LIGHTS - LED TAIL STROBE LIGHT INSTALLATION WITH 130-3070-0001 KIT INSTALLED

The original LED tail nav/strobe light is no longer available. A new LED tail nav/strobe light is available as a replacement.

MTB-33-05
Page 1 of 10

Figure 1. Before Modification (Sheet 1)

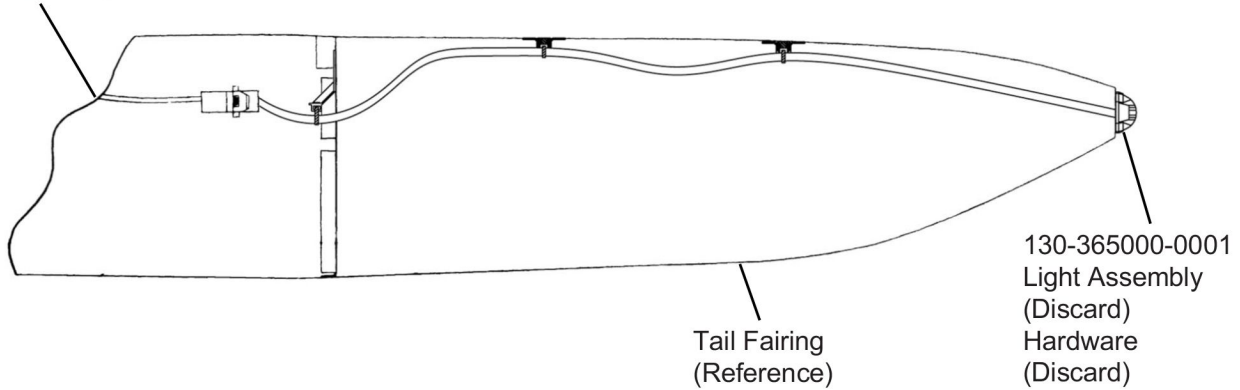
- C. Remove the aft tail fairing.
 3. (Refer to Figure 1, Sheet 1.) Remove the aft tail strobe light assembly and wiring as follows:
 - A. Remove and discard the hardware that attaches the 130-365000-0001 Light Assembly to the tail fairing.

- B. Discard the 130-365000-0001 Light Assembly and the associated harness.
 4. (Refer to Figure 2, Sheets 1 and 2.) Do the wiring modification to the airplane wiring harness as follows:

Figure 2. Wiring Modifications (Sheet 1)

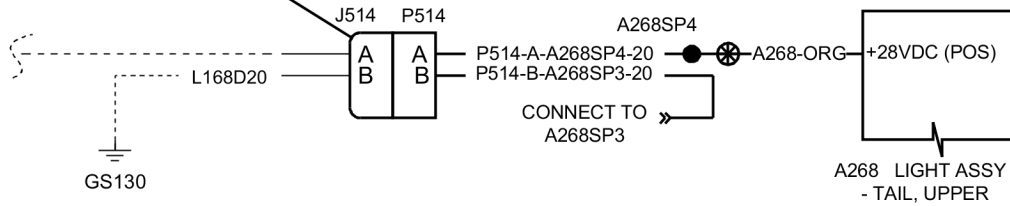
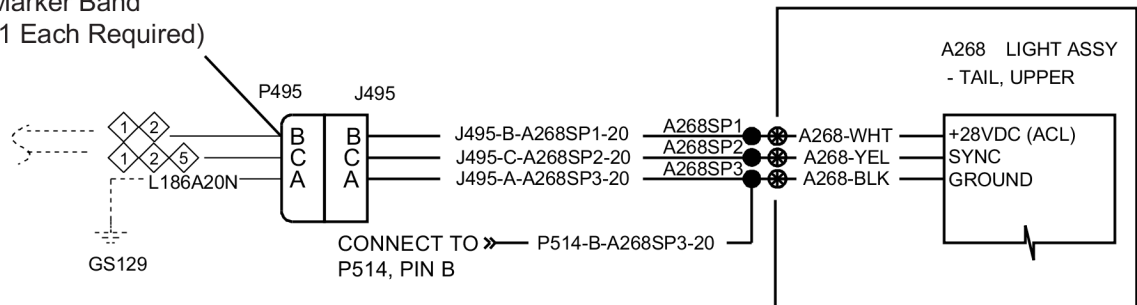
- A. Remove and discard the P495 Connector.
 - B. Install a SJS840400 Pin Receptacle two M39029/58-364 Contact Pins and two MS27488-16 Sealing Plugs onto the existing airplane wiring harness.

- C. Install a SJS840410 Pin Plug with three M39029/57-358 Sockets and one MS27488-16 Sealing Plug onto the existing airplane wiring harness.
 - D. Install and label each connector using one 131741-3 Marker Band onto the airplane wiring harness.

Figure 3. After Modification (Sheet 1)

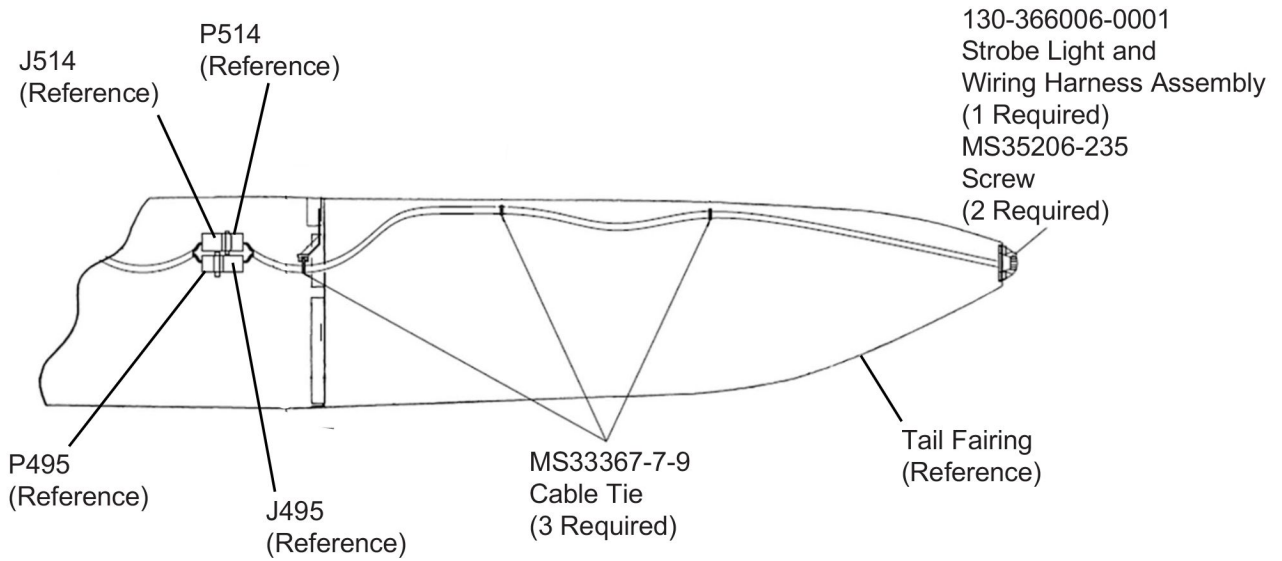
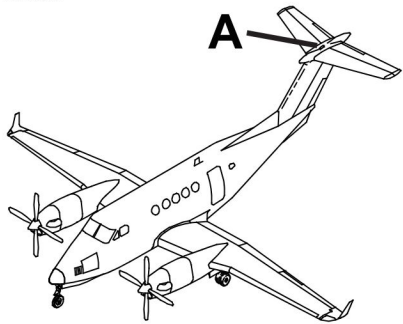
5. (Refer to Figure 3, Sheet 1.) Install the 130-366006-0001 Strobe Light and Wiring Harness Assembly as follows:
 - A. Install the wiring harness of the 130-366006-0001 Strobe Light and Wiring Harness Assembly from the aft end of the tail fairing.

- B. Electrically bond the 130-366006-0001 Strobe Light and Wiring Harness Assembly to the aft end of the tail fairing.
 - (1) Apply adequate U470638 Sealant between the 130-366006-0001 Strobe Light and Wiring Harness Assembly and tail fairing.

NOTE: The U470638 Sealant should squeeze out when the two MS35206-235 Screws are installed.
 - (2) Install two MS35206-235 Screws through the 130-366006-0001 Strobe Light and Wiring Harness Assembly and the tail fairing.
 - (3) Make sure to clean off excess sealant between the 130-366006-0001 Strobe Light and Wiring Harness Assembly and the tail fairing with Isopropyl Alcohol.
 - (4) Make sure that the electrical bond is no more than 0.01 Ohms.
 - C. Attach the wiring harness from the 130-366006-0001 Strobe Light and Wiring Harness Assembly with one MS3367-7-9 Cable Tie to each of the mounts attached to the tail fairing and bulkhead.
 - D. Install the tail fairing.
 - E. Connect the wiring connectors as follows:
 - (1) Connect J495 to P495.
 - (2) Connect P514 to J514.
